Access Compliance Report Public Rights-of-Way (Island Curb Cuts)

Main Street: NARROW_CANYON_RD		Cross Street: NARROW_CANYON_RD		Location:	W
ADA ID: CCRK211103162636	Curb Cut Type: MedianRefuge2	Initial Pass/Fail: Pass	Overall Compliance: No	Severity Score:	15
Codes/Mitigation Info/Possible Solution			Field Measurements/Component Compliance

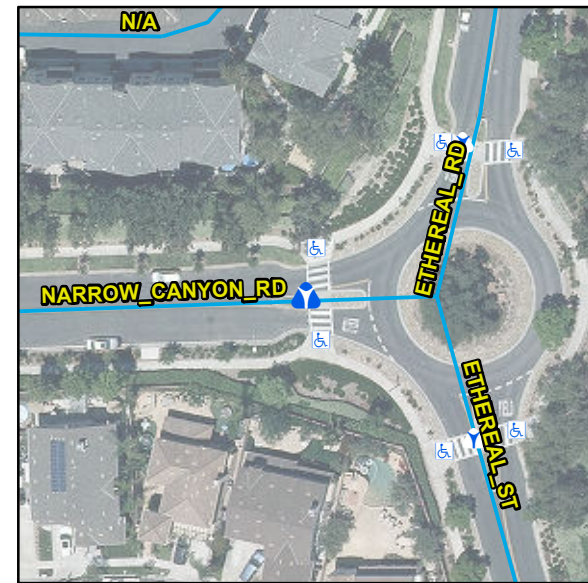
Compliance	Description	Data	Compliance	Description	Data
Yes	Refuge 1 Length (In)	56	Yes	Guttter 1 Ponding	No
Yes	Refuge 1 Width (In)	96	Yes	Gutter 1 Lip Ht (In)	0
Yes	Refuge 1 Slope (%)	0.8	Yes	Gutter 1 Slope (%)	0.5
Yes	Refuge 1 Cross Slope (%)	1.9	No	Gutter 1 Cross Slope (%)	2.4
N/A	Painted Cross Walk 1	Yes	No	DWS 1 Provided	No
	Cross Walk 1 Direction	N	N/A	DWS 1 Contrast	N/A
	Cross Walk 1 Width (In)	145	N/A	DWS 1 Length (In)	N/A
Yes	Refuge Inside Cross Walk 1	Yes	N/A	DWS 1 Full Width	N/A
	Road 1 Slope (%)	2.2	N/A	DWS 1 Offset (In)	N/A
	Road 1 Cross Slope (%)	1.3			N/A
Yes	Refuge 2 Length (In)	56	Yes	Guttter 2 Ponding	No
Yes	Refuge 2 Width (In)	96	Yes	Gutter 2 Lip Ht (In)	0
Yes	Refuge 2 Slope (%)	2	Yes	Gutter 2 Slope (%)	1.2
Yes	Refuge 2 Cross Slope (%)	2	Yes	Gutter 2 Cross Slope (%)	0.8
N/A	Painted Cross Walk 2	Yes	No	DWS 2 Provided	No
	Cross Walk 2 Direction	S	N/A	DWS 2 Contrast	N/A
	Cross Walk 2 Width (In)	144	N/A	DWS 2 Length (In)	N/A

Install Detectable Warning System. Remove & Replace Gutter.
